<b>AMENDMENT OF SOLICITATION/MODIFICATION OF CONTRACT</b>			1. CONTRACT ID CODE	PAGE 1 OF 5 PAGES
2. AMENDMENT/MODIFICATION NO. AMENDMENT NO. 0005		3. EFFECTIVE DATE 09/12/12	4. REQUISITION/PURCHASE REQ. NO.	5. PROJECT NO. (If applicable) 11-0207
6. ISSUED BY CODE eaw Officer in Charge of Construction MCI-East 1005 Michael Road Camp Lejeune, NC 28547-2521		7. ADMINISTERED BY (If other than Item 6) CODE See Item 6		
8. NAME AND ADDRESS OF CONTRACTOR (No., street, county, State and ZIP Code)			(X)	9A. AMENDMENT OF SOLICITATION NO. N40085-11-R-0207
			X	9B. DATED (SEE ITEM 11) 08/09/12
				10A. MODIFICATION OF CONTRACT/ORDER NO.
				10B. DATED (SEE ITEM 11)
CODE	FACILITY CODE

11-0207, Repair Flight Simulator Facility, Bldg AS320

Proposals received at 1500 hours on 27 August 2012 are hereby cancelled. Revisions to the RFP are hereby incorporated in accordance with the attached.

1. The date and time for receipt of revised proposals is hereby extended to 0900 on 14 September 2012.
2. The attached revised E-1 and E-4 sheets include Shunt Trip Breakers on the panels serving the simulator equipment and related computers and controllers (See clouded areas for changes). E-1: Equipment Conn

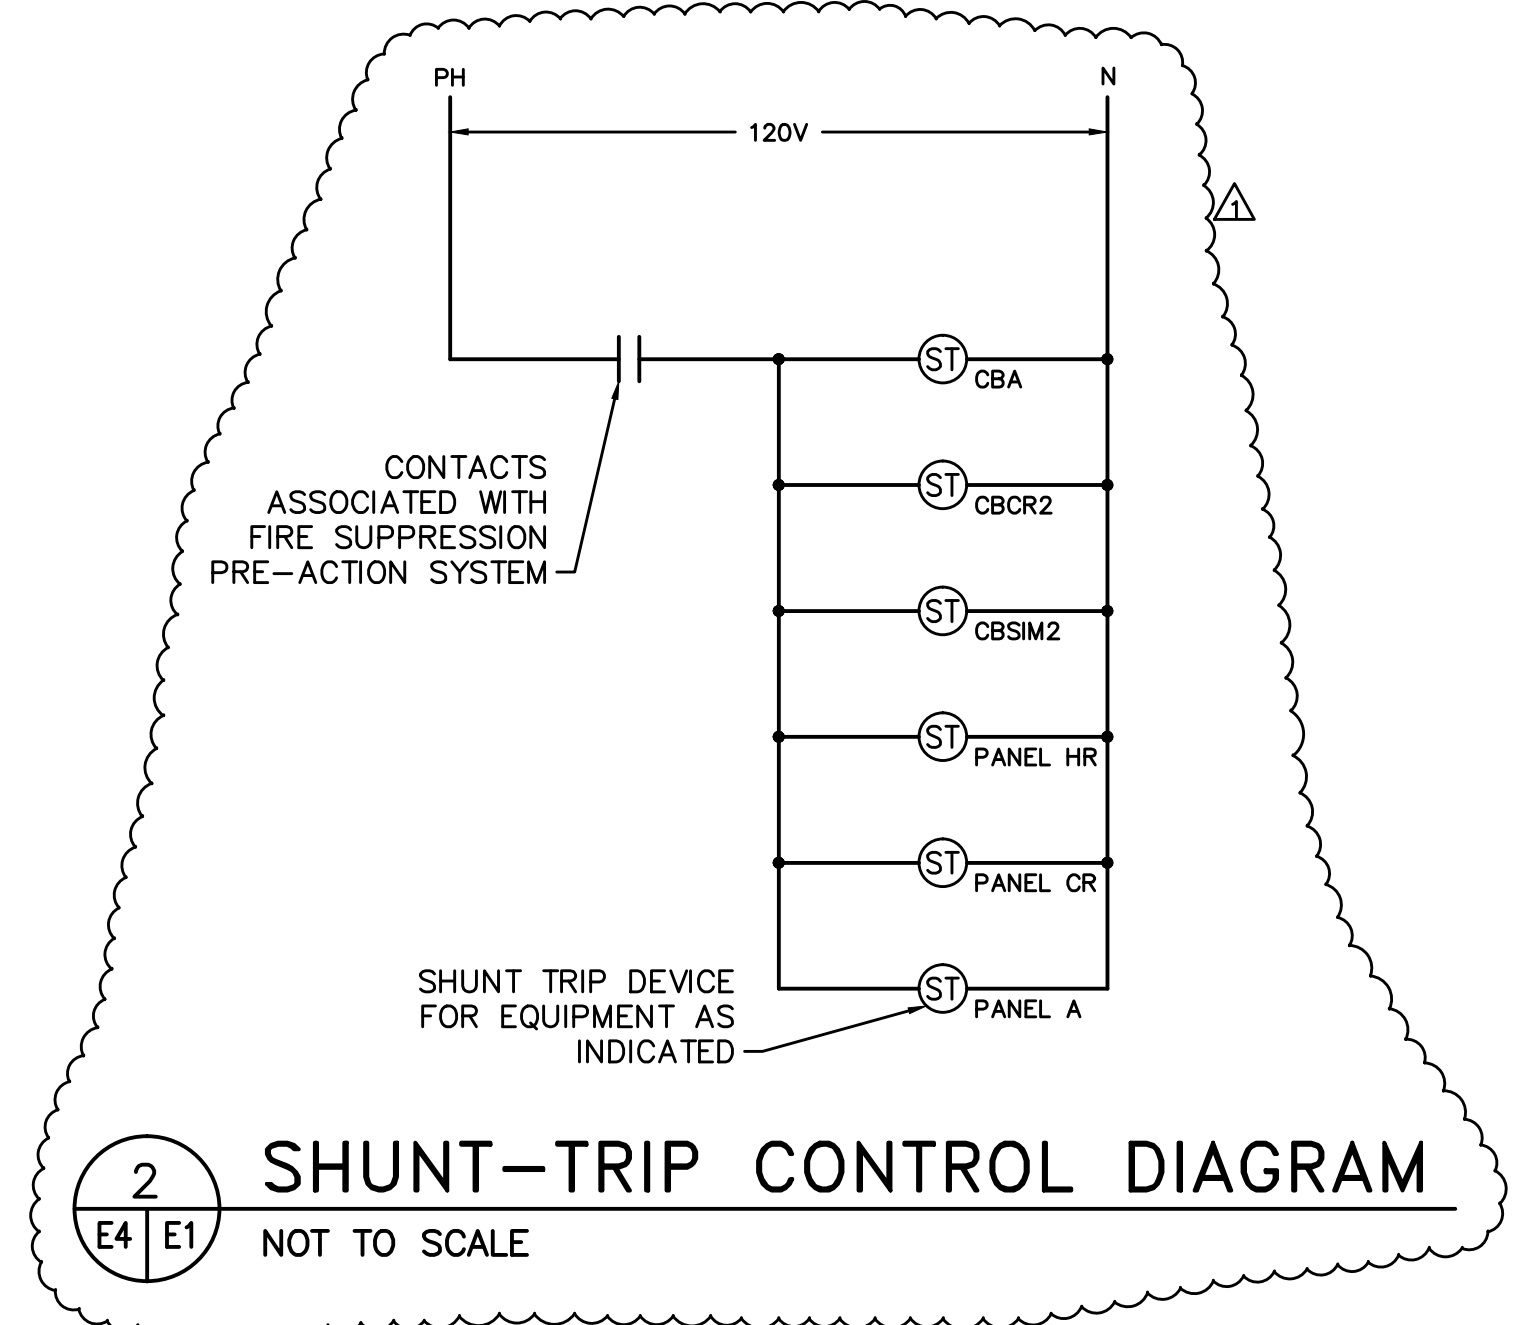
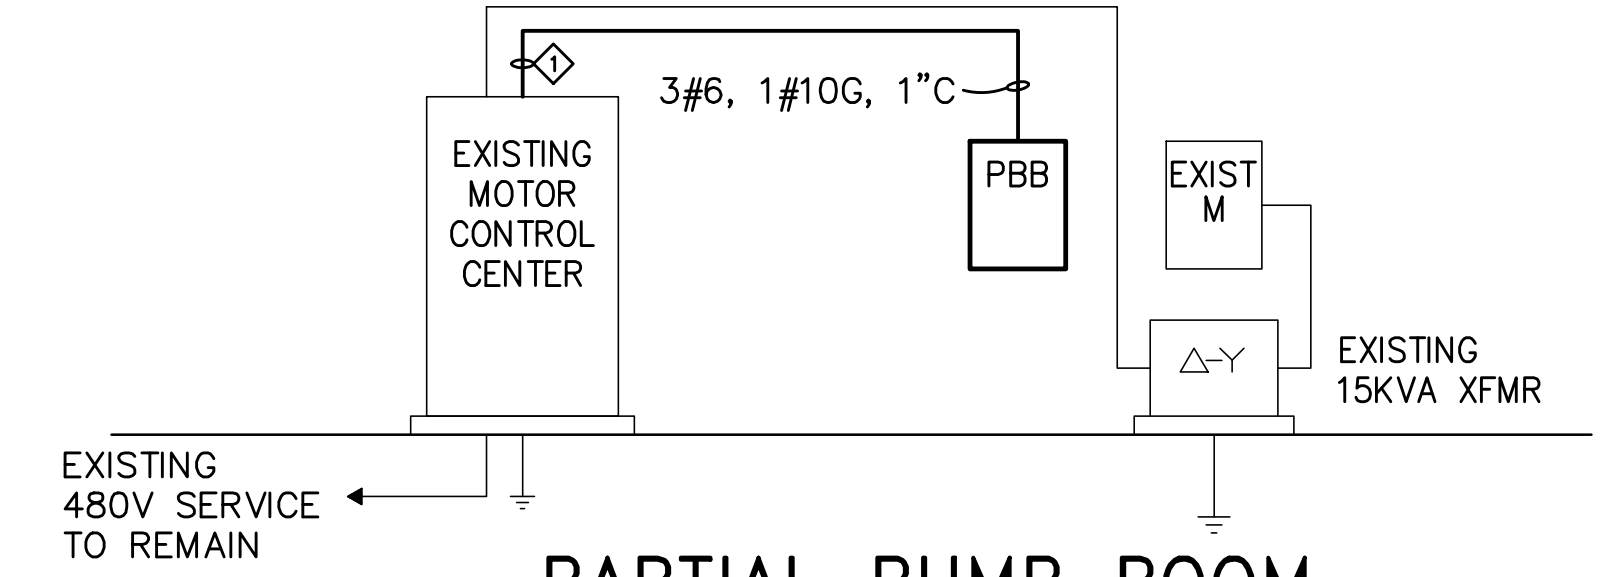
◇ PROVIDE CIRCUIT BREAKER WITH SHUNT-TRIP DEVICE.

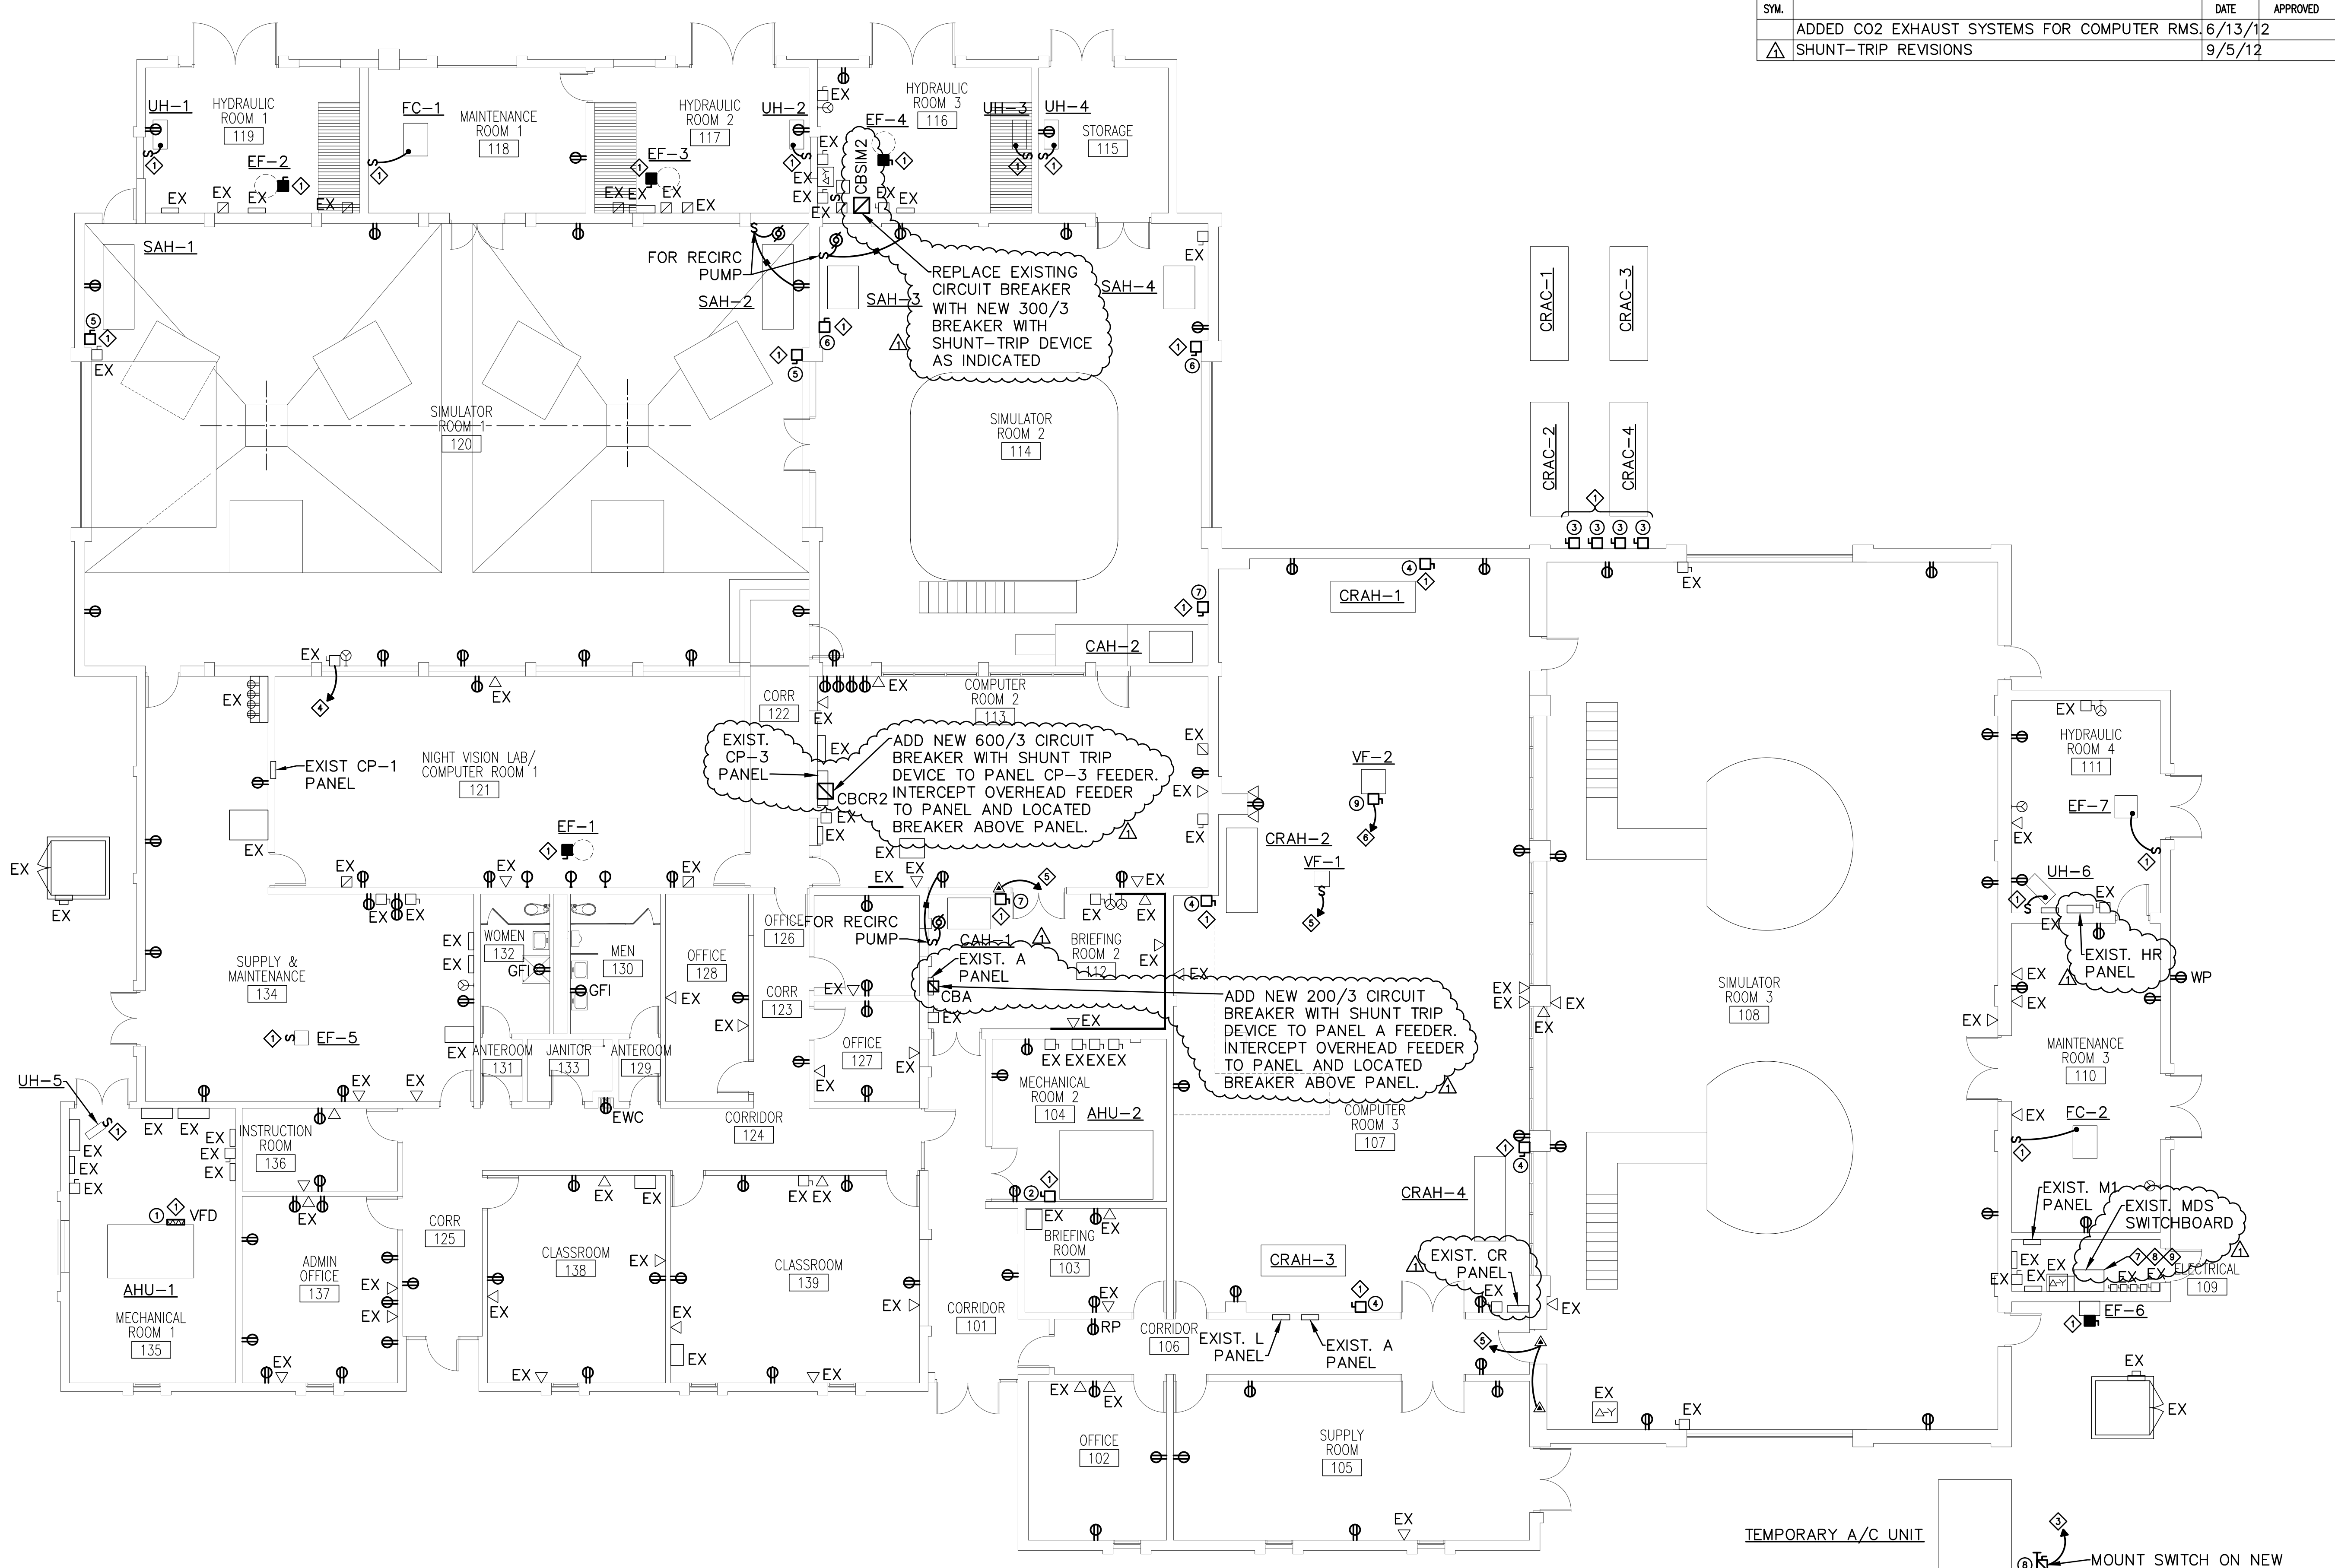
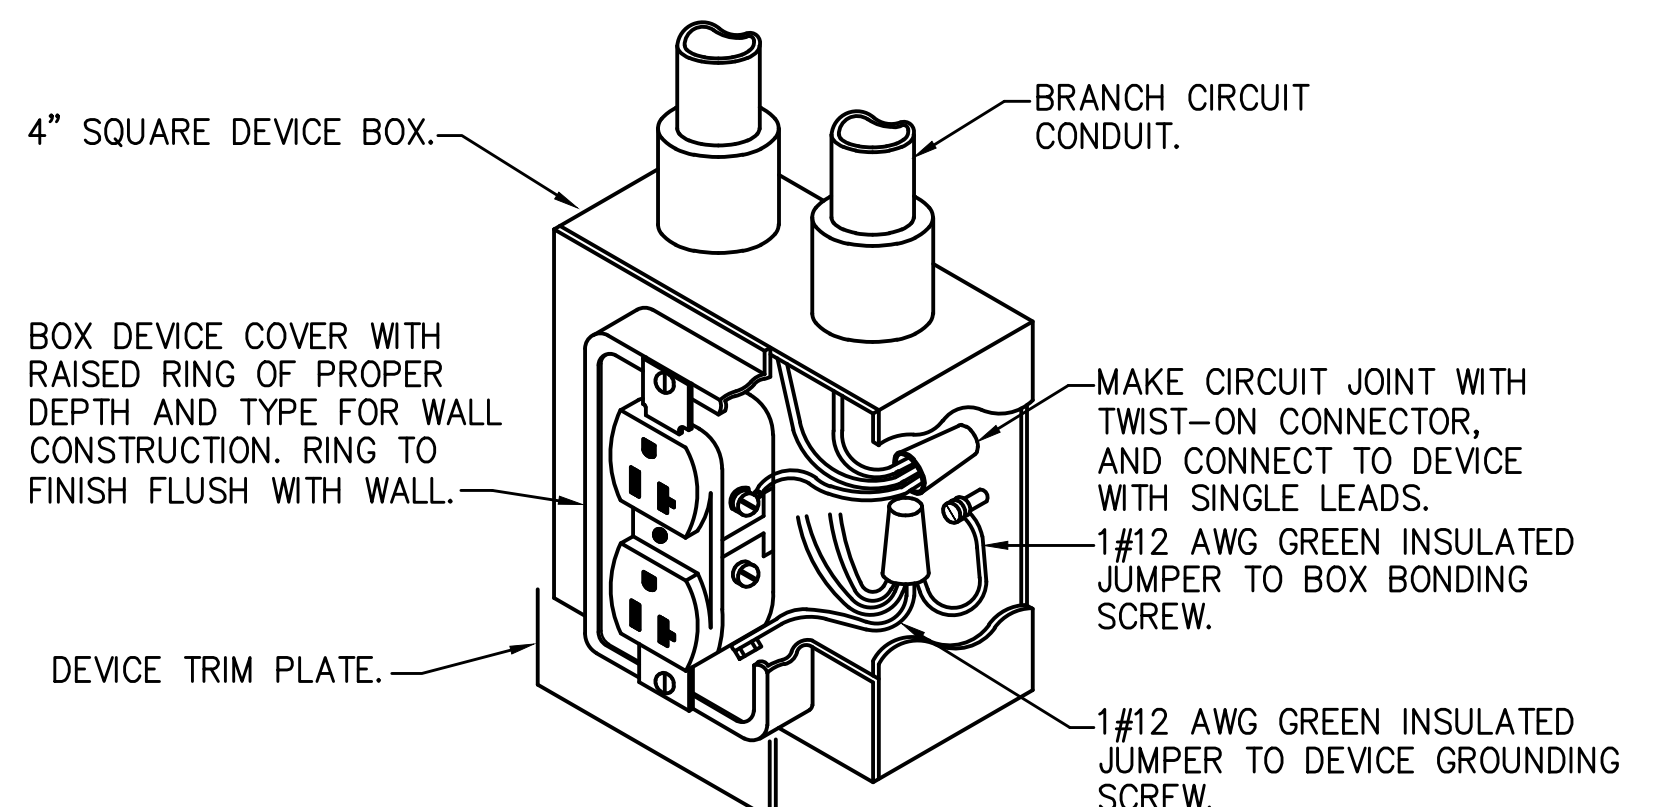
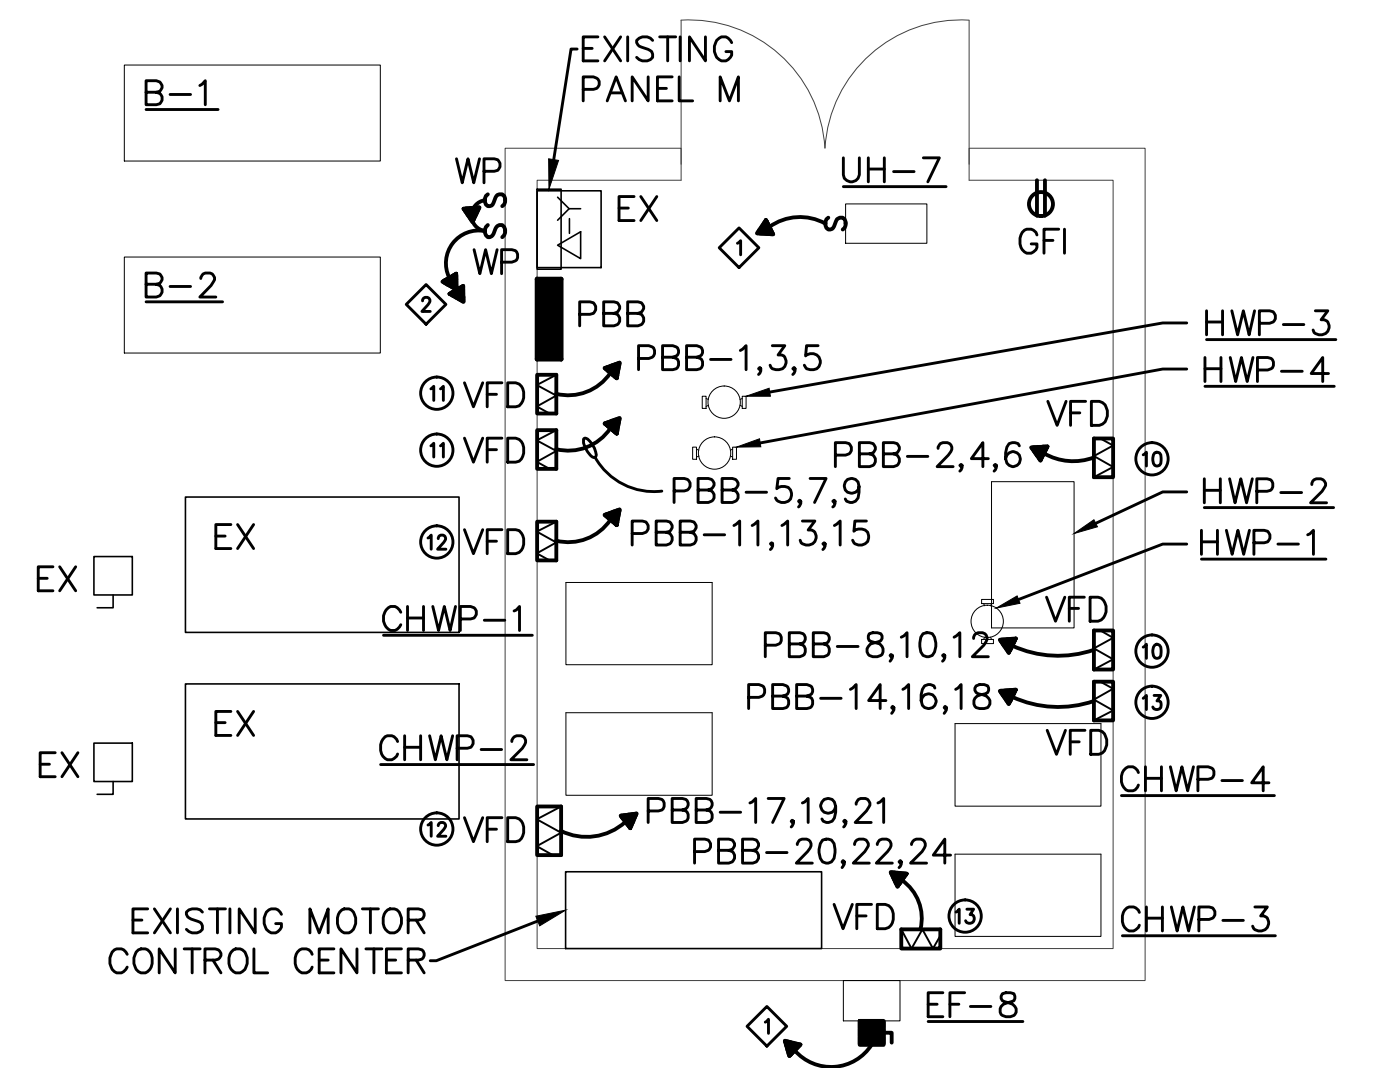
- REMOVE EXISTING 400/3 CIRCUIT BREAKER FOR PANEL HR IN EXISTING SWITCHBOARD MDS (GE AV-LINE). REPLACE WITH NEW GE SPECTRA LINE 400/3 CIRCUIT BREAKER WITH SHUNT TRIP DEVICE.

- NOTES:
- REMOVE EXISTING CIRCUIT BREAKER FOR PANEL CR VIA XFMR T1 IN EXISTING SWITCHBOARD MDS (GE AV-LINE). REPLACE WITH NEW GE SPECTRA LINE 400/3 CIRCUIT BREAKER WITH SHUNT TRIP DEVICE.
  - REMOVE EXISTING CIRCUIT BREAKER FOR PANEL A VIA XFMR T2 IN EXISTING SWITCHBOARD MDS (GE AV-LINE). REPLACE WITH NEW GE SPECTRA LINE 100/3 CIRCUIT BREAKER WITH SHUNT TRIP DEVICE.
